Our reference: R/2022/2/A

Your reference: SSD-38600121

Subject: Advice on EIS - Alexandria Health Centre - 28-32 Bourke Road, Alexandria

Figure 1: Indicative street section for Bourke Street, showing the 4 storey street wall behind the 2.4m footpath widening, and the 12m upper level setback behind (draft SDCP 2012 - Southern Enterprise Area)

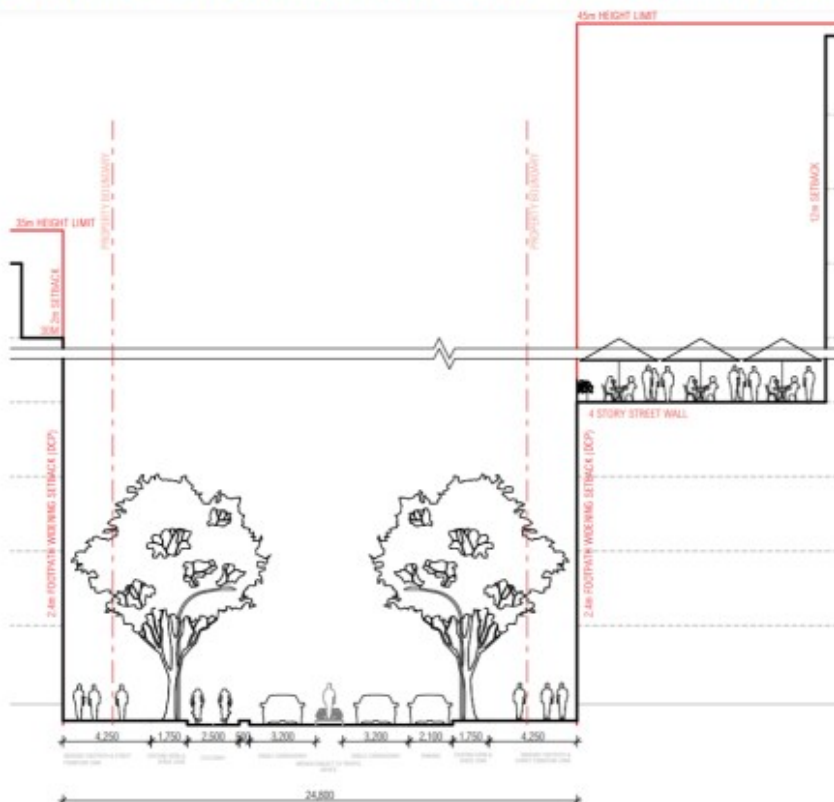
Figure 1 below demonstrates the anticipated built form for the site outlined in the draft DCP, which includes a 4 storey street wall built to the Bourke road frontage with a 12 metre upper level setback behind. This site is not specified in the DCP as requiring a landscape setback.

The proposed reference scheme does not follow the setbacks envisaged in the DCP. Instead, it proposes a 12 metre setback on the ground floor and above, with deep soil and landscaping within the front setback. The Urban Design report states that the 4 storey street wall is achieved through an architectural screen, which building users will pass under as they enter the building and the landscaped area would sit behind this screen.

The absence of providing the 4 storey street wall on Bourke Road risks the building not adequately relating to the adjacent future development along Bourke Road. The street wall plays an important role in defining the spatial structure of a place. It defines the 'space' of the street, provides visual cut off from the street to the taller building behind the setback, creates a consistent built form along the street by linking one building to another and minimises 'perceived' density by creating a continuous wall along the street with appropriate articulation. In addition, the street wall avoids the negative impact of exposed boundary walls for 12 metres in the view along the street and strengthen legibility by clearly indicating 'gaps' in the street wall where the cross streets and lanes are located.

The street wall is an important mechanism for defining space in an urban area and cannot be resolved through an architectural screen. The City does not support the proposed architectural screen and this should be removed from the concept proposal.

If the 4 storey street frontage height is not pursued, then the following issues must be resolved:

- The proposed lift at the front of the site on Bourke Road is not supported. This area is flood prone and is therefore a poor location for a lift. Further, the City considers these types of lifts to be a very poor way of providing equitable access for all people and this is particularly problematic given the use of the building as a hospital. As a minimum, the lift should be relocated to be inside the building. Alternatively, replacing the lift with a ramp system inside the building would provide a far superior outcome for future users of the site.
- The power supply kiosks must be relocated. They are currently located within the deep soil zone and in a flood prone part of the site.
- The deep soil zone must be increased (see Point 4 below) and the basement wall facing Bourke Road will need to be relocated.
- The architectural screen must be removed.

Figure 2: Extent of minimum required master grading work (shown in red) and longitudinal master grading exercise scope (shown in blue).

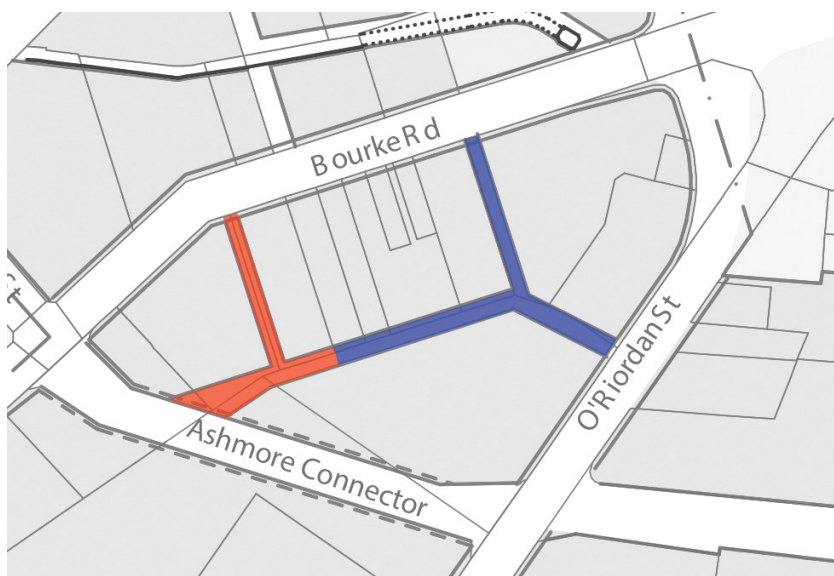
The City has previously advised the applicant in pre-application discussions of the minimum extent of master grading work that will need to be undertaken to support future development on the site (shown in red in the figure below). In addition to this, the above mentioned longitudinal master grading exercise will need to be undertaken for the entire block, as shown in blue below.

- A longitudinal section is required for the new road along the western boundary. It is to be extended along the southern side of the site up to the connection point with the surrounding Bourke Road & O'Riordan Street. The section must start from the ridge point of Bourke Road and continue through the centre line of the new road along the western side, then to O'Riordan Street centre line. In addition, a longitudinal section through the future Through Site Link between the site and Ashmore Connector is required. The section is to be taken along the centre line of the Link.

- An additional long section is to be taken from the ridge point of Bourke Road and continue through the centre line of a new road (required further east from the site) to the above long section.

- Sections must include existing and proposed levels and must indicate longitudinal gradient/slope and vertical curve (*IP* "Ingress Protection"), allowing a vehicle to negotiate the elevation rate change at a gradual rate rather than a sharp cut.
